To: Planning and Zoning Committee
From: Aimee Nassif, Senior Planner of Zoning Administration
Date: 9/17/2007
RE: **P.Z. 34-2007 Blue Ocean (Johnny Y Properties)**: A request for a change of zoning from "M3" Planned Industrial District to "PC" Planned Commercial District for 2.7 acre tracts of land located south of US Highway 40&61, east of Chesterfield Commons Drive (17T230123, 17T230112). Proposed Uses include: Restaurants, sit down.

Planning Commission Staff Report

Petition: P.Z. 34-2007 Blue Ocean (Johnny Y Properties)

RE: **P.Z. 34-2007 Blue Ocean (Johnny Y Properties)**

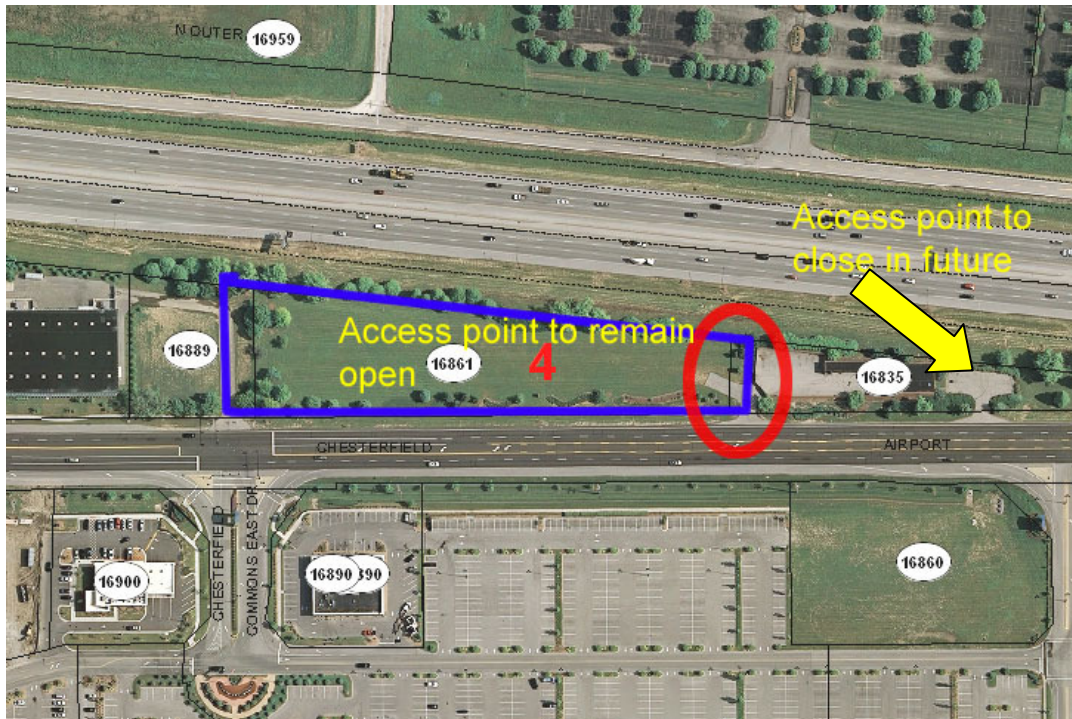
An issue was raised regarding the access to the site from Chesterfield Airport Road; specifically the access on the easternmost end of the site. Below is a rendering which depicts that existing access which is shared with the Sach's Maintenance Facility (and is circled in red). The Department of Planning and Public Works has communicated to the Petitioner that if at such time the Sach's Maintenance Facility site comes in to develop, the City will request that the access point on the east side of the Facility building be eliminated. Petitioner has agreed with to eliminate this easternmost access point when the site comes in to be developed.

A PRELIMINARY DEVELOPMENT PLAN OF BLUE OCEAN

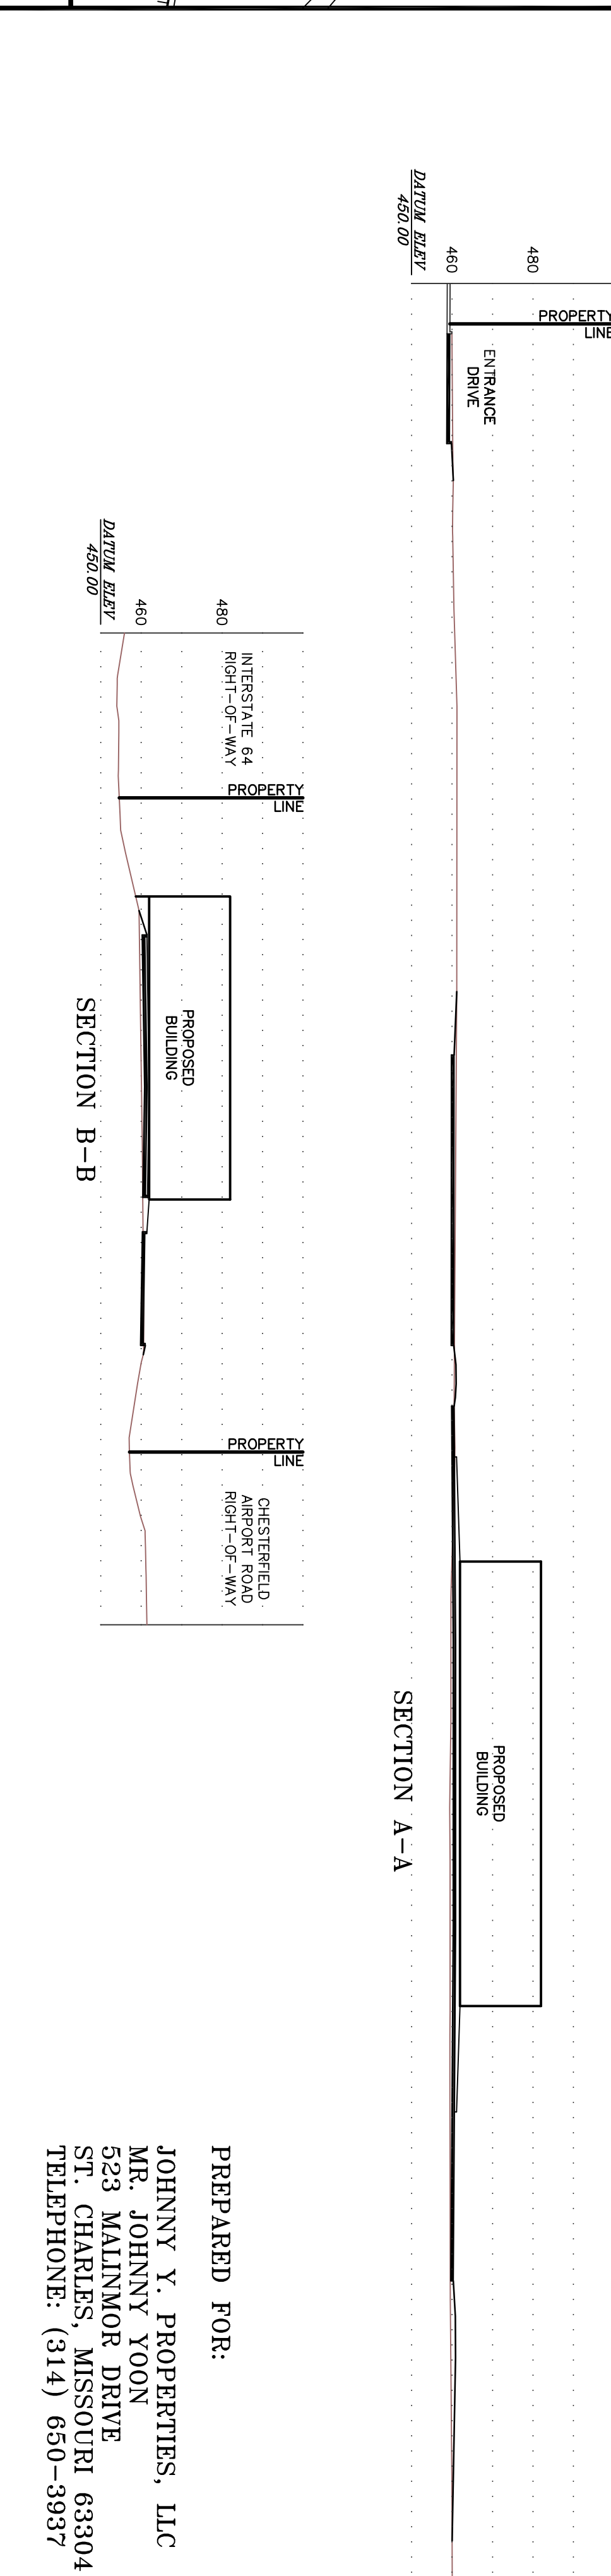
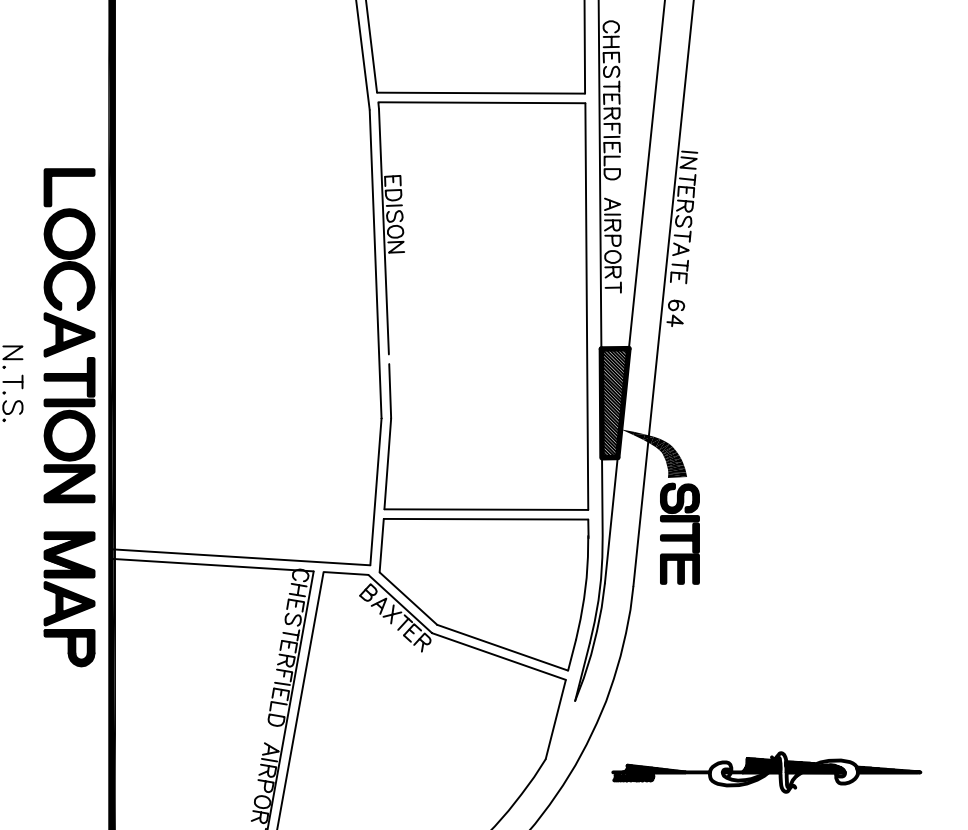
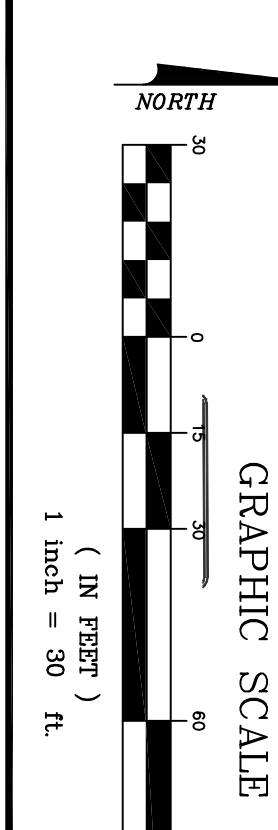
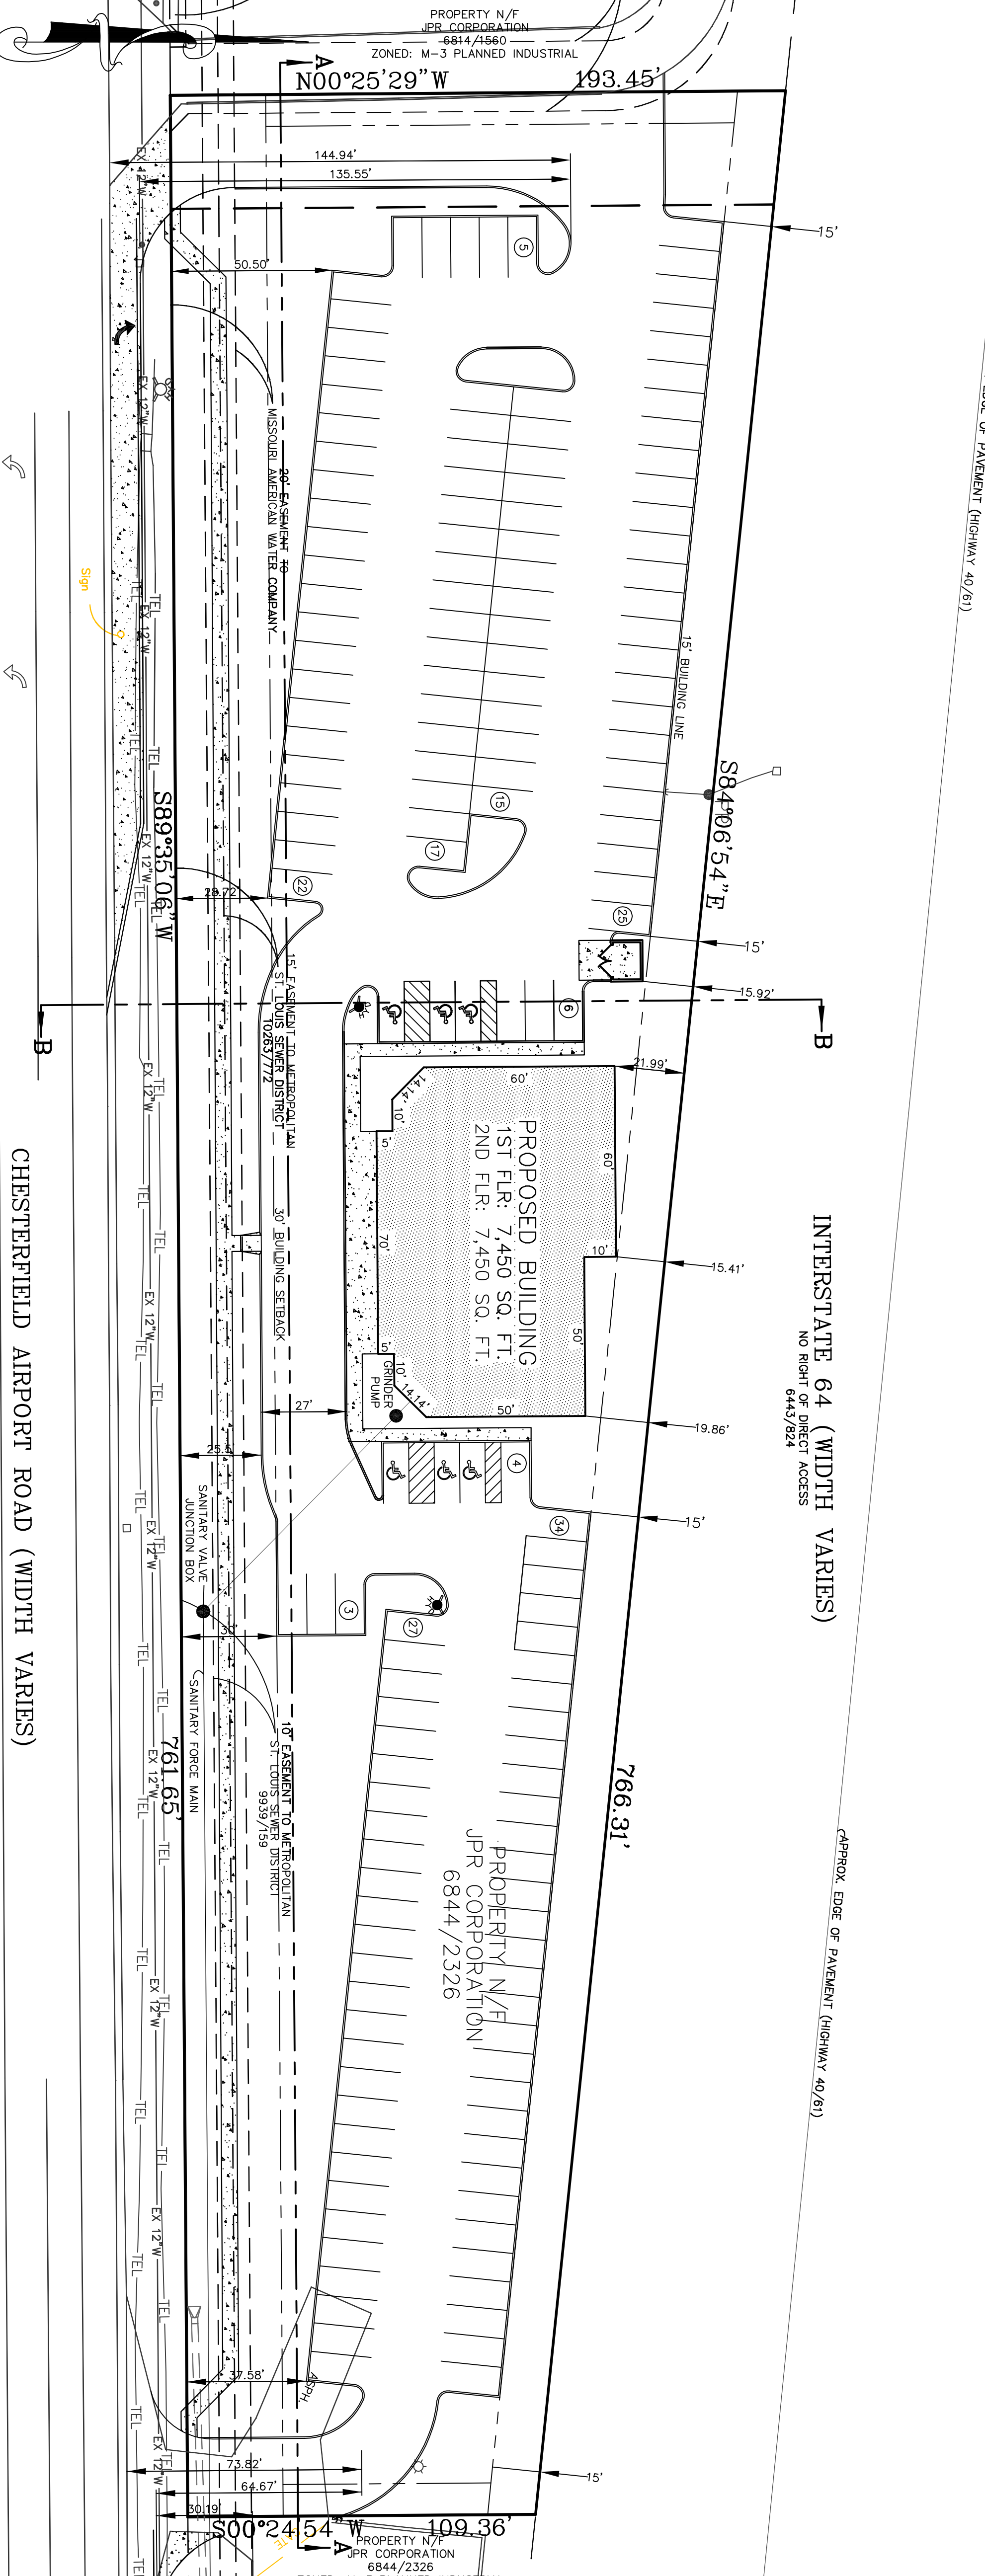
1. There is concern regarding the vehicular and pedestrian circulation throughout the site.
Response: Petitioner has made the changes to the site plan requested by Monarch Fire to meet their minimum turning radii. Petitioner believes the revised site plan, submitted herewith, otherwise complies with the requirements of the City of Chesterfield and provides adequate, safe and appropriate circulation for both vehicular and pedestrian traffic.

2. Address the concern regarding both of the access points for this development. Specifically, concern regarding the access point on the eastern end of the development site.

3. Parking spaces on the east side of the site should not be situated so that cars will back into the entrance drive.

4. Provide comments/approval from the Monarch Fire Protection District.

Response: The access proposed on the west side is a shared access for both the subject site and the Kemp Museum property to the west and is centered across from the existing access on the south side of Airport Road. The access, as proposed, meets St. Louis County Traffic's requirements and Chesterfield's requirements, as well as Monarch's requirements in all respects. The access proposed for the east side of the subject property is an existing access, and provides access to the subject site as well as the existing site to the East. As Mike Geisel indicated, Petitioner would agree to the elimination of the existing second access on the east side of the adjacent parcel, if and when that property is redeveloped, and use the proposed access as shown on the site plan for access to both parcels. Elimination of the current proposed east-shared access would result in significant loss of parking, making the proposed use economically unfeasible.

Response: The revised site plan eliminates the parking stalls that create the conflict.

Response: Petitioner has met with David Nichols of Monarch Fire Protection District, who reviewed and agreed on the necessary changes to the internal drive radii. The revised site plan modifies the turning radii in a manner to meet their requirements. A copy of Monarch's specifications and requirements are attached. The revised site plan has been provided to Mr. Nichols, and he has agreed to make every effort to respond to the revised site plan before the next meeting of the Commission, but could not provide a response today. We hope that the attached specifications will allow staff to confirm that the revised site plan does meet Monarch's requirements and address their previous comments.
